ITASCA DOCUMENT REVIEW

Document Title: "Modification of Rock Mass Permeability in the Zone Surrounding a Shaft in Fractured, Welded Tuff" by John B. Case and Peter C. Kelsall (SAND86-7001, March 1987)

Reviewer: Itasca Consulting Group, Inc. (L. Lorig)

Fig. 1 Simplified Damaged Zone Model Used in Original Performance Analysis Study Presented in Appendix B of Letter from D. L. Vieth to J. J. Linehan (15 July 1985)

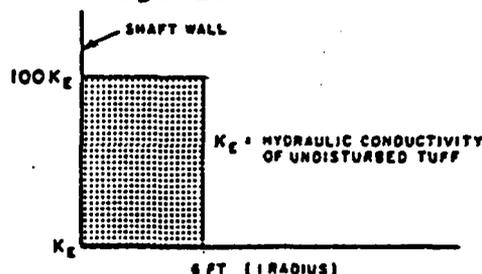
This model was not based on a "site-specific evaluation of the degree of damage likely to be associated with shaft construction in tuff" (Vieth, Appendix B, p. 5). Subsequently, NRC requested DOE to provide it "with the data (e.g., RQD's, stresses, hydraulic conductivities used to get the results presented during DOE presentation of the damaged zone model for tuff" (Open Item 18 of NRC-NNWSIP Exploratory Shaft Design Construction Meeting Summary, August 27-28, 1985).
